October 6, 2017

Geotechnical Report Addendum and
Statement of Risk
Detached Garage
3603 West Mercer Way
Mercer Island, Washington
Parcel No: 3623500260
Doc ID: FatBoyCon.WMercerWay.RGA(1)

Figure 1

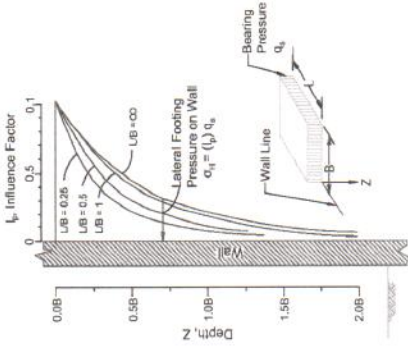
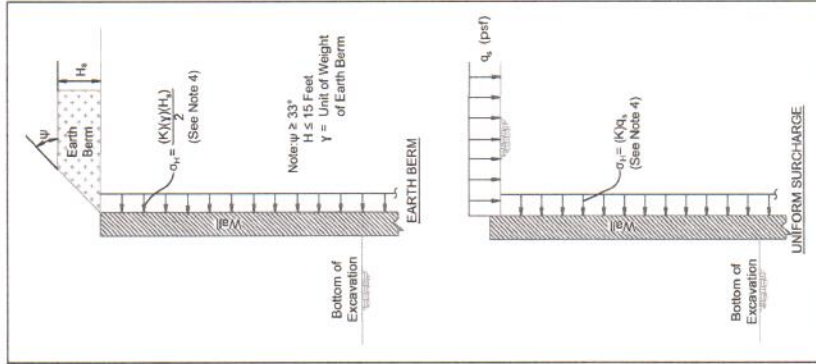
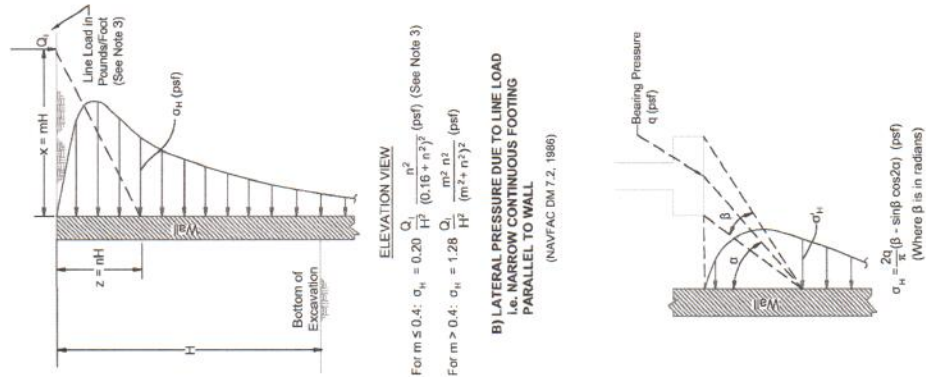
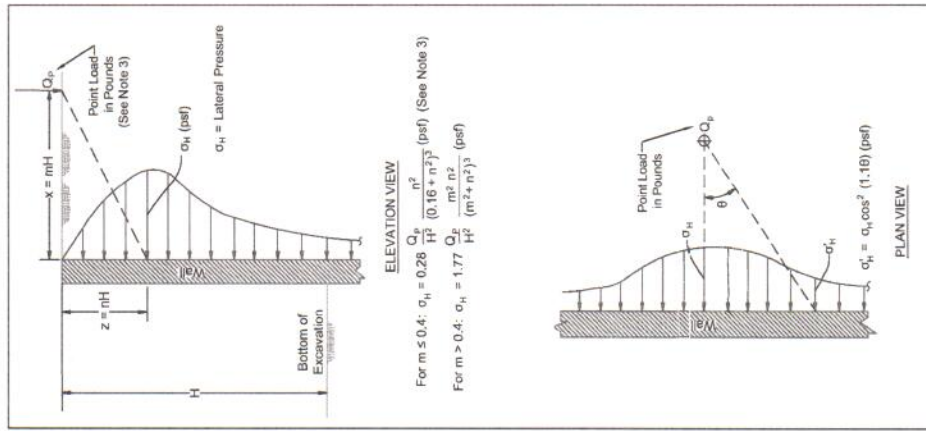
Design of the below grade structures may be performed using the earth pressures and loading diagrams provided in Figures 1 and 2. A 2,500 psf surcharge was used to model the slope above the main cut. This should only be applied in this area. A seismic surcharge is provided based on the IBC seismic coefficient and the Mononobe-Okabe analysis. This surcharge should be applied uniformly as required by the code.
